Board of Education Regular Meeting

Project Title:
CHASE COUNTY K-12 SCHOOL - GYM ADDITION
 520 EAST 9TH STREET
 IMPERIAL, NE 69033
 CHASE COUNTY SCHOOLS

From: Joey Lefdal <jlefdal@chasecountyschools.org> 
Subject: Fwd: Questions
Date: April 12, 2016 at 10:19 AM
To: woneil57@gmail.com, stevenwallin189@gmail.com, tgaschler@fvcoop.com, danreeves@gpcom.net

From: Jamie Winters <jamie@studio120arch.com>
Subject: RE: Questions
Date: April 11, 2016 at 5:33:06 PM MDT
To: Joey Lefdal <jlefdal@chasecountyschools.org>

Sheet No.
A-0.01

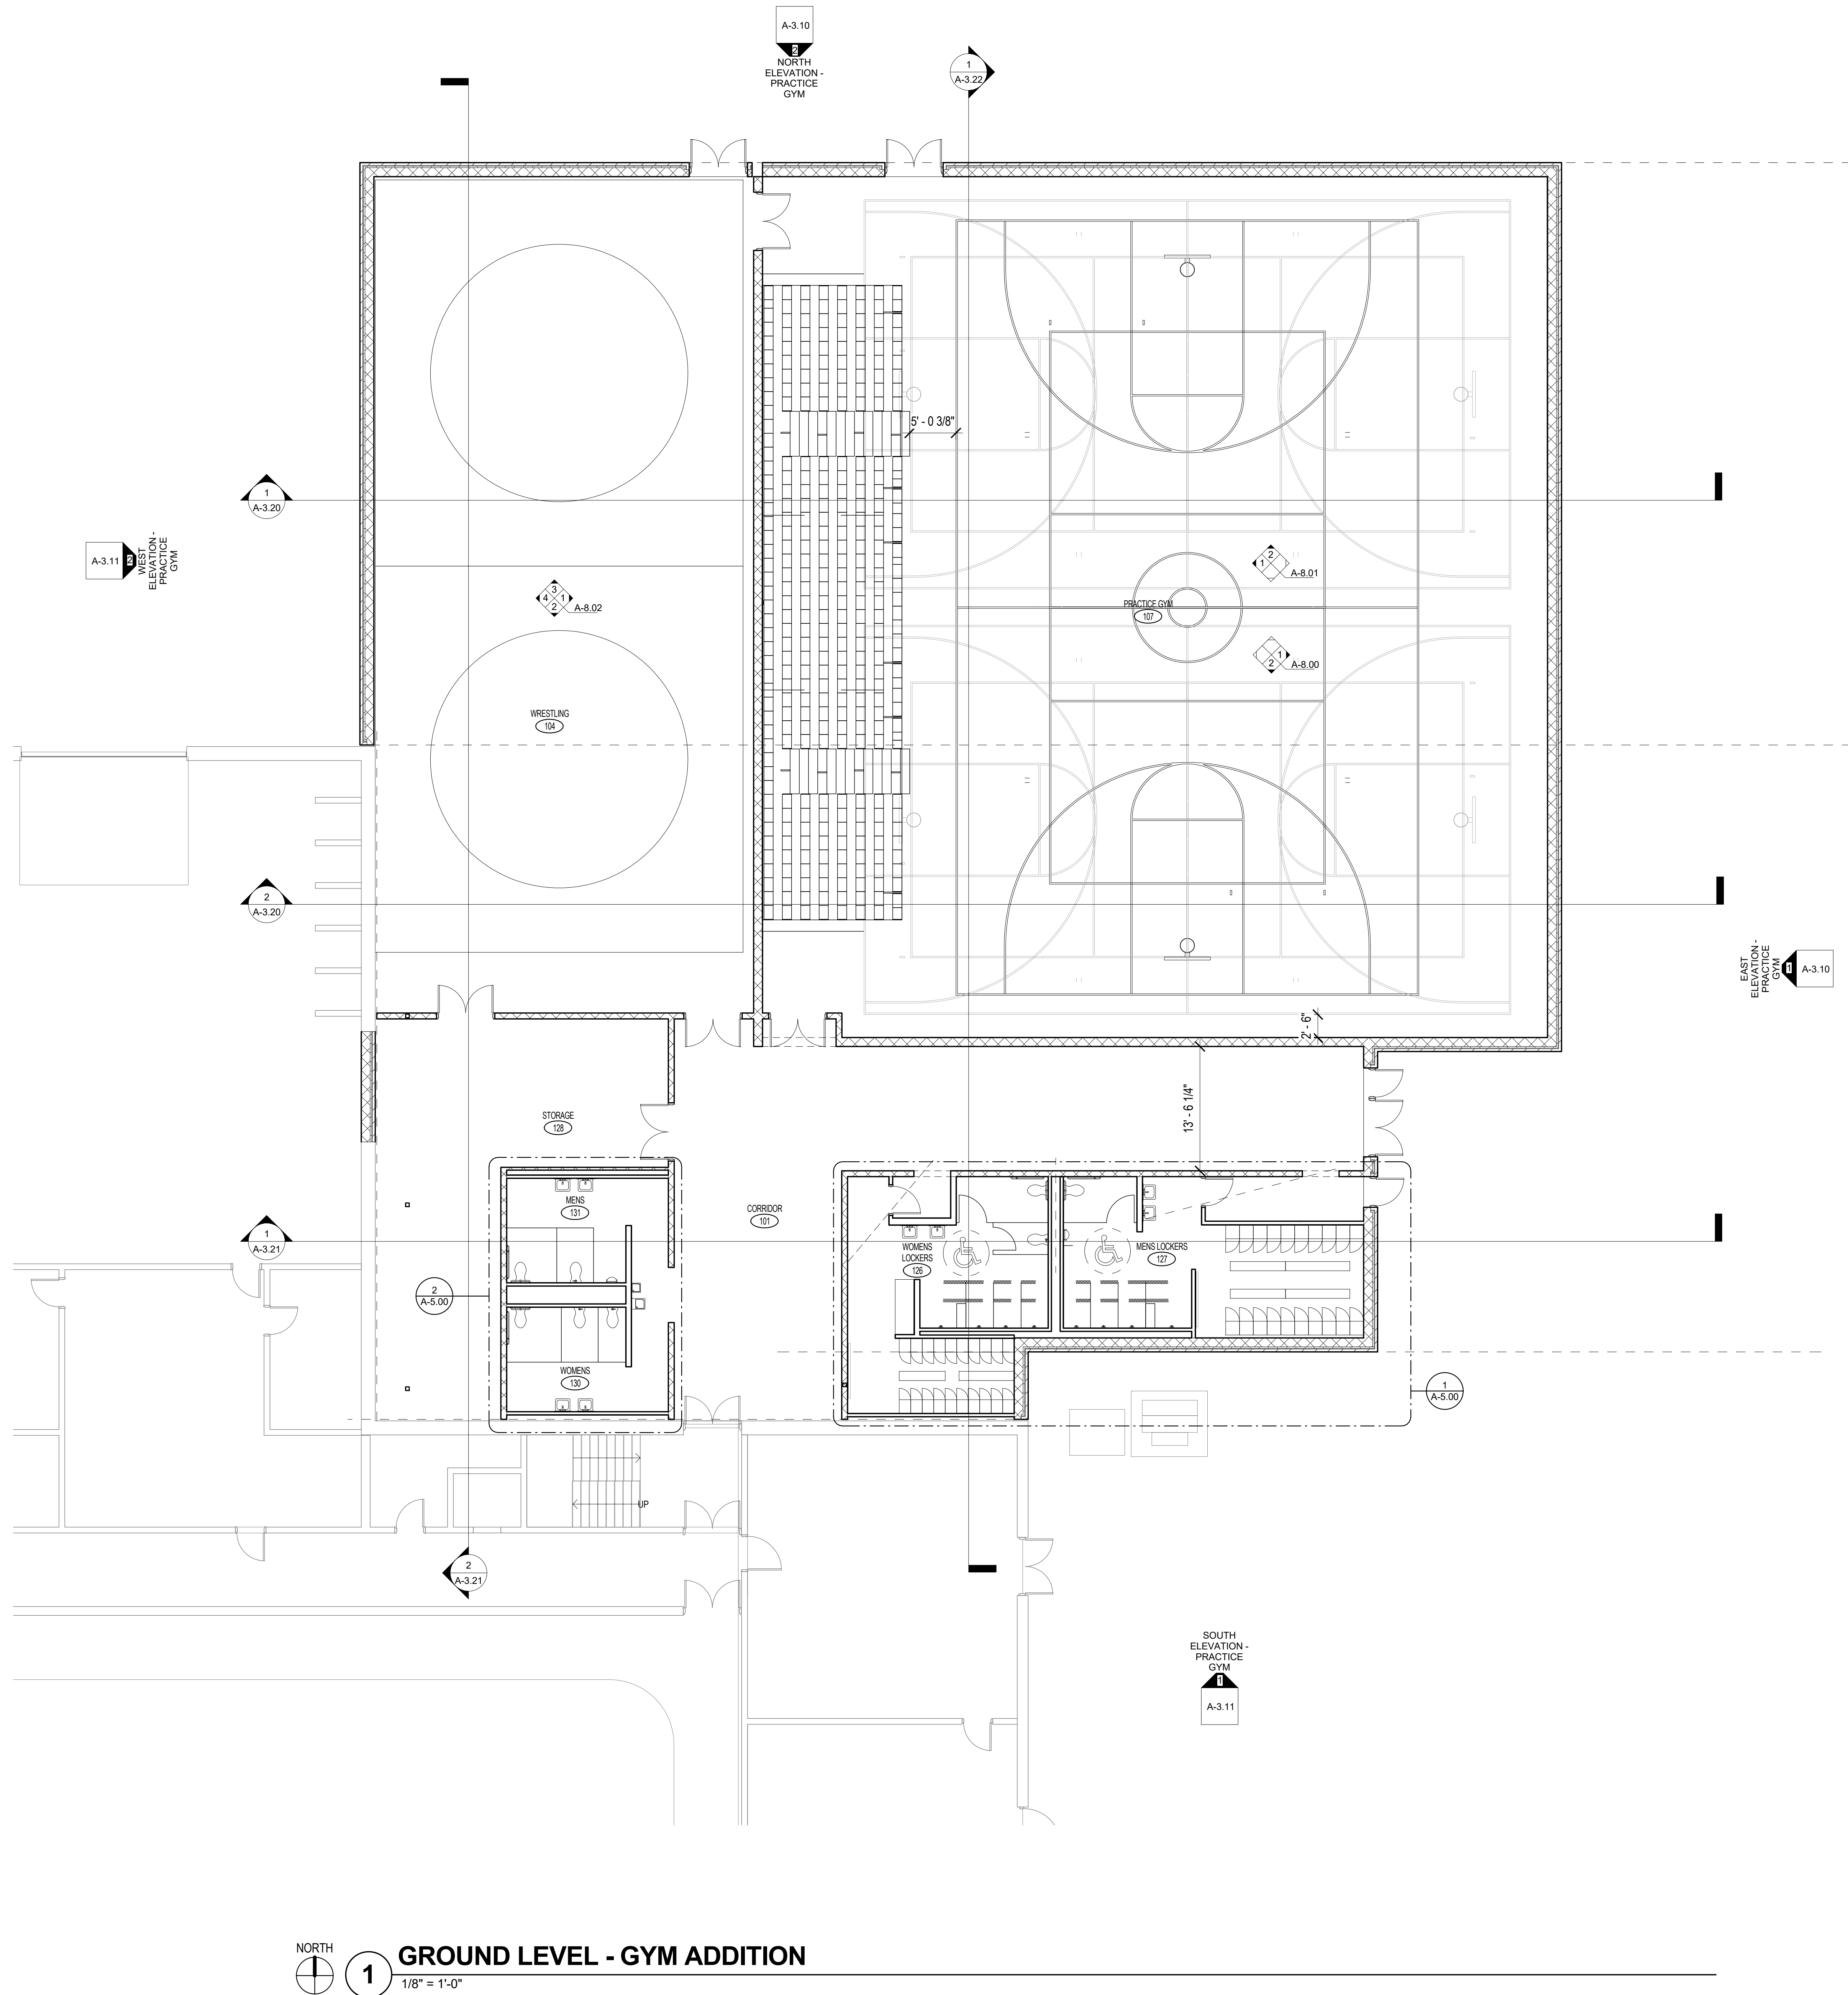
- Class bell and intercom system – We will provide new speakers tied back into the existing high school zone. Each speaker will have volume control at the speakers. In reviewing with the Vendor, this approach will allow the school to replace the headend but be able to reuse the speakers and wire when they upgrade. It sounds like this has been in the works for a few years so we want to be sure to accommodate.

- Communications – We currently have some distance limitations getting new communications cabling from the addition back to the existing communications room. Our intent will be to provide a small 2' tall wall mount rack in the storage room to support local comm cabling and then tie back to the main telecom room with fiber. Can you review with the Owner and let us know if you both are on board with this approach.

- Cameras – We currently do not have in our contract to provide the camera system but we will indicate jboxes at each exterior door for future cameras. We are not planning on rough-ins for interior cameras as those are usually easy to install. Please let us know if this sounds appropriate.

- Electrical – We are currently planning on locating the electrical panels within the storage room per our discussion on site.
- Lighting cut sheets are attached. Please let us know if you take an exception to any and we can reselect.
- I1 – Gym and wrestling room. Will have an acrylic lens.
- I2 – Storage Room
- A1 – Corridor
- D1 – Locker/rest room Will have recessed acrylics too.
